3.3.3 London Borough of Hillingdon - Pre-app 3 - 24th March 2023

3.3.4 London Borough of Hillingdon - Pre-app 4 - 19th August 2024

3.3.5 London Borough of Hillingdon - Pre-app 5 - 21st July 2025

3.3.6 GLA Pre-App - 13th August 2025

3.5.2 Phase 2 Massing Summary

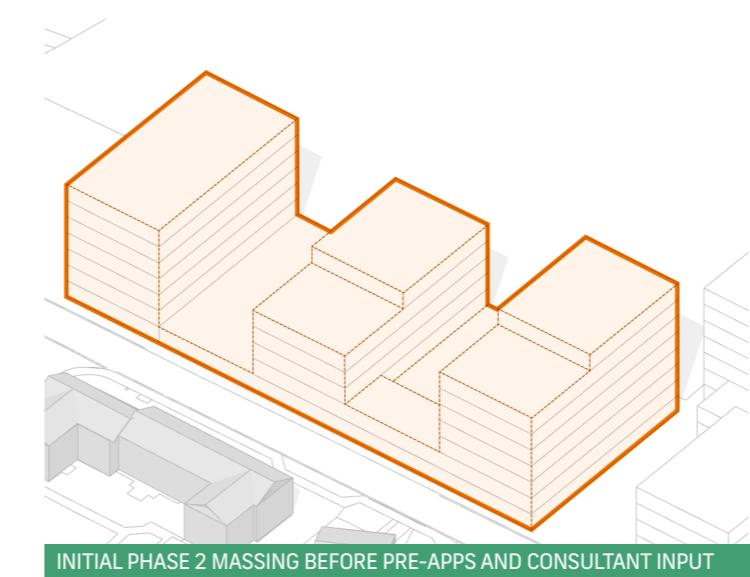
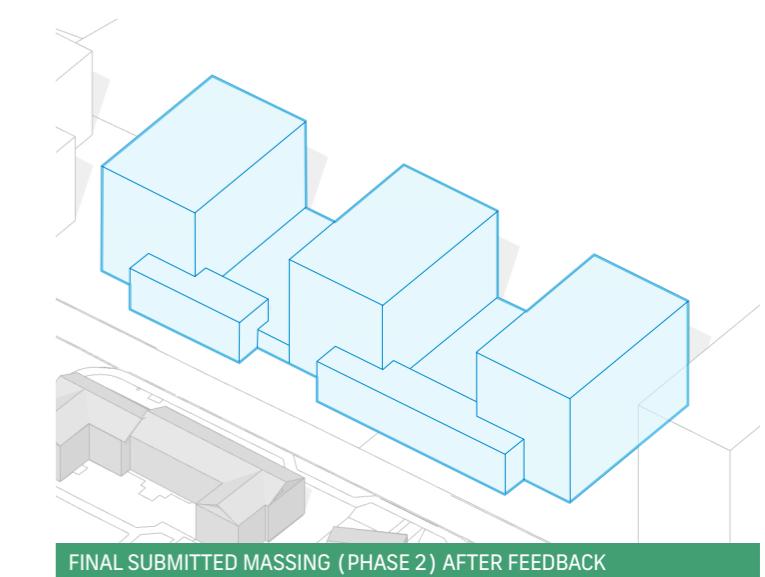
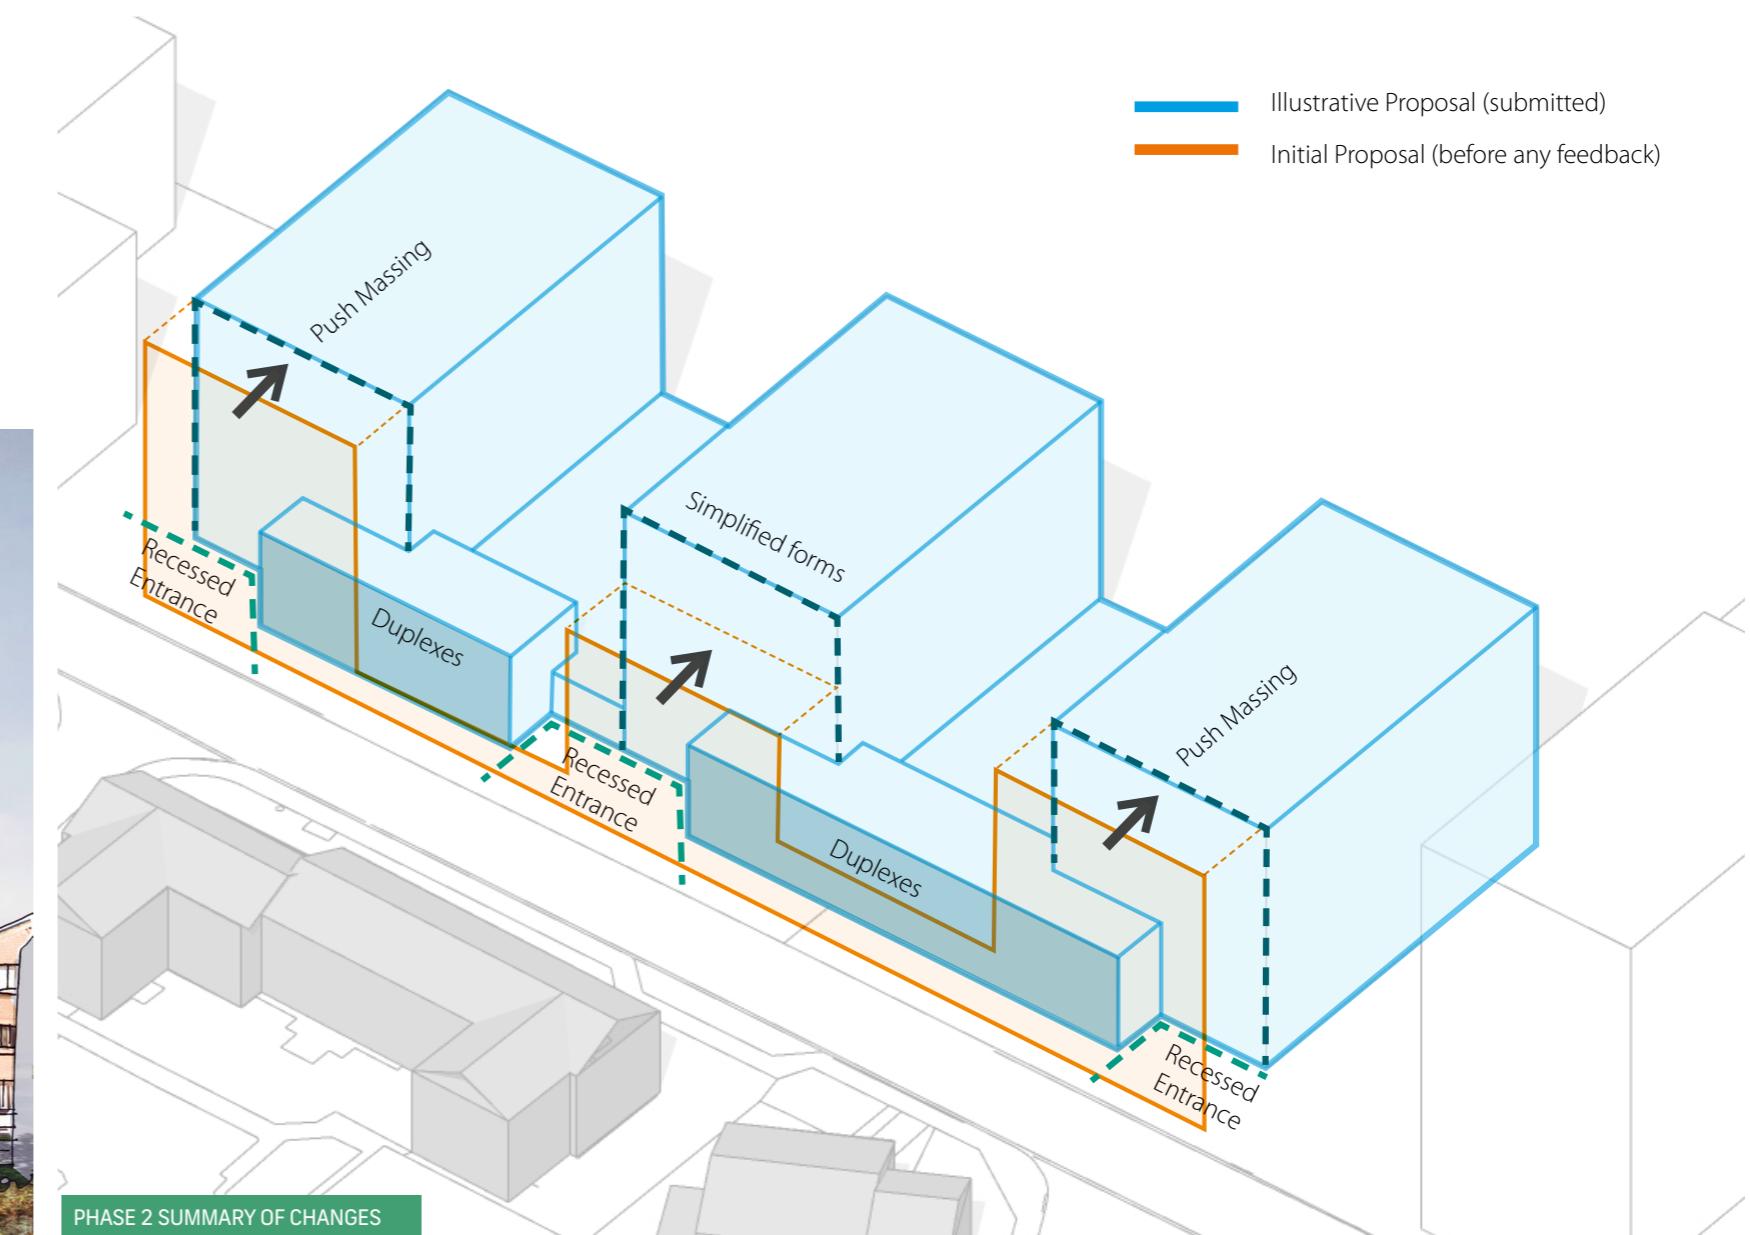
The set back edge of development along Avondale Drive and Abbotswood Way was questioned during the pre-application design stages, with the LPA's preference of aligning the front of phase 2 with phase 1A ultimately settled on. This allows a good amount of defensible space buffering the proposed duplexes from the pavement.

The final submitted massing also provides good relief to the street frontage by setting back the mid-scale blocks further, helping to define the streetscape with 2-storey duplexes that relate to a human scale and that of the existing residential context. Pockets of space are created around the entrances to the mid-scale blocks.

3.5.3 Phase 1B Summary

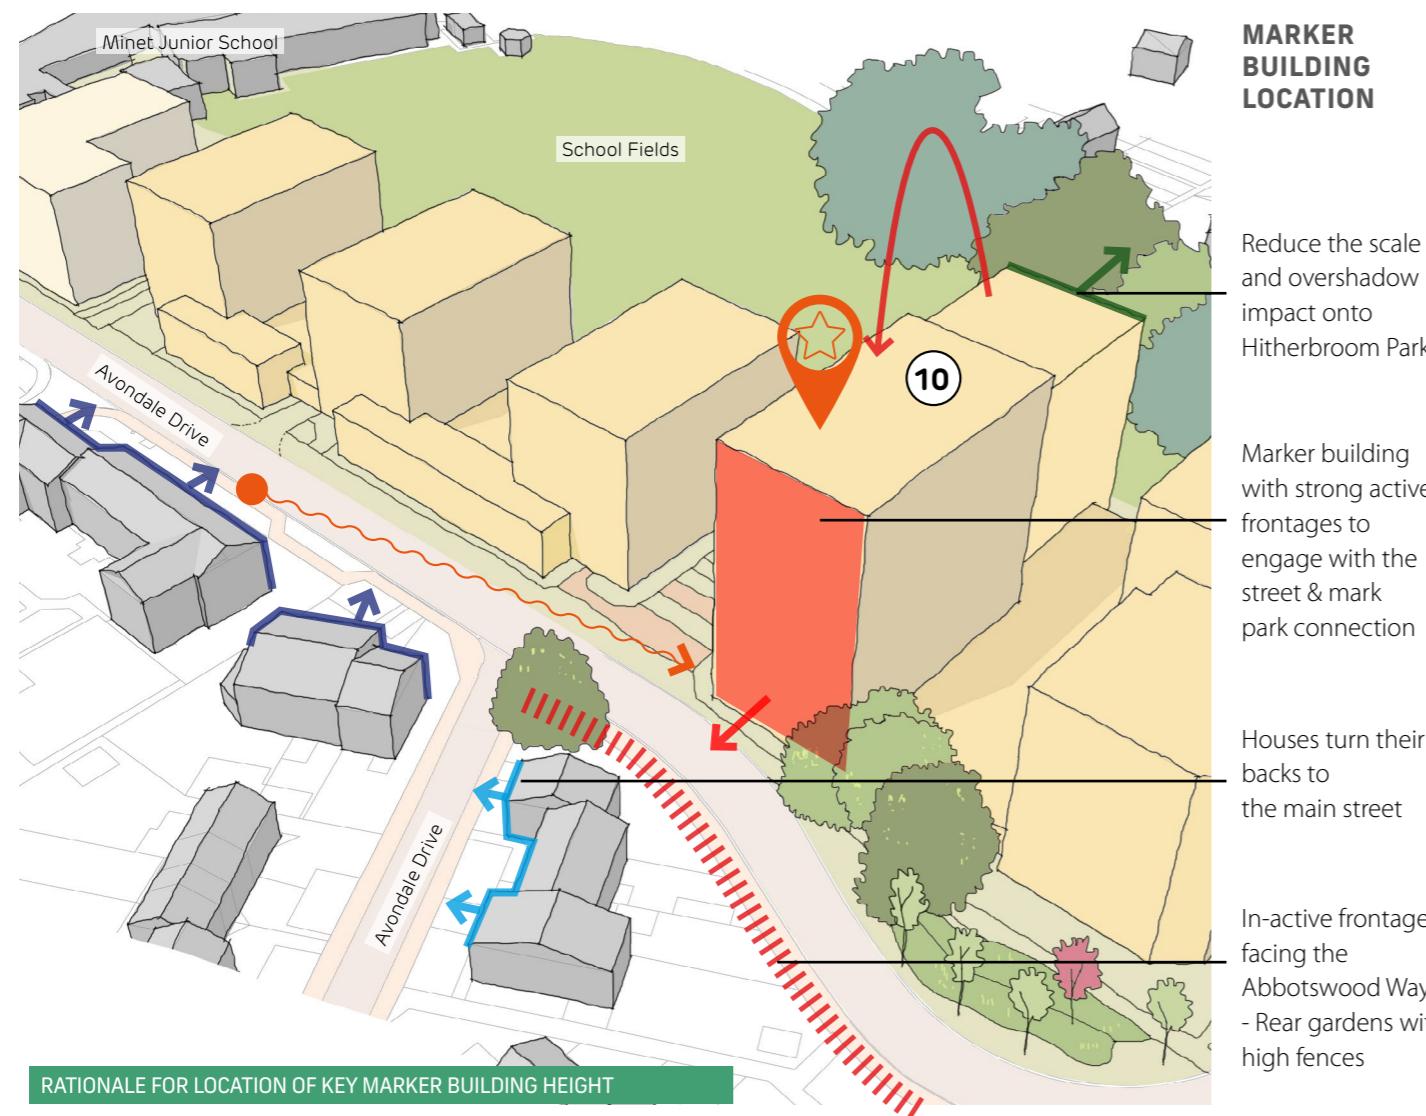
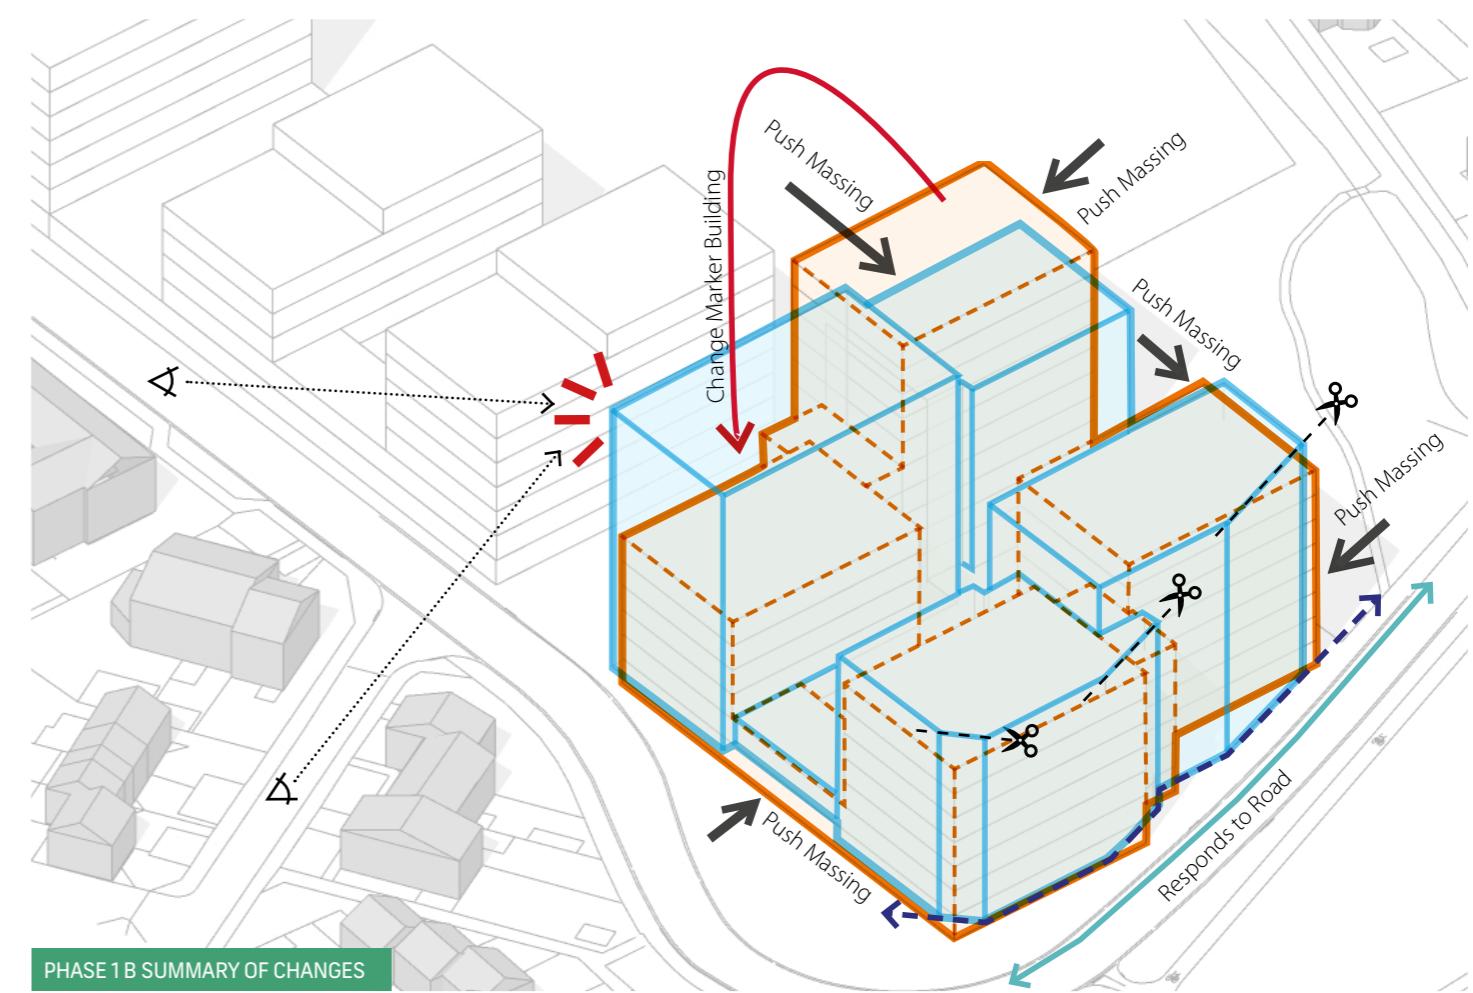
Our original proposals included the tallest element in the NW corner of phase 1B however concerns were raised regarding overshadowing Hitherbroom Park. The height was suggested to be moved to the South-East corner to mark the public space, providing good placemaking and way-finding benefits. Daylight/sunlight studies confirmed the changes to nearby dwellings were insignificant, and the park's overshadowing reduced.

The transitional corner between Avondale Drive and Abbottswood Way has also been tested throughout the design process. A chamfered corner has been agreed to work best from the streetscape, and the frontage along Abbottswood Way has been shaped to respond to the road.
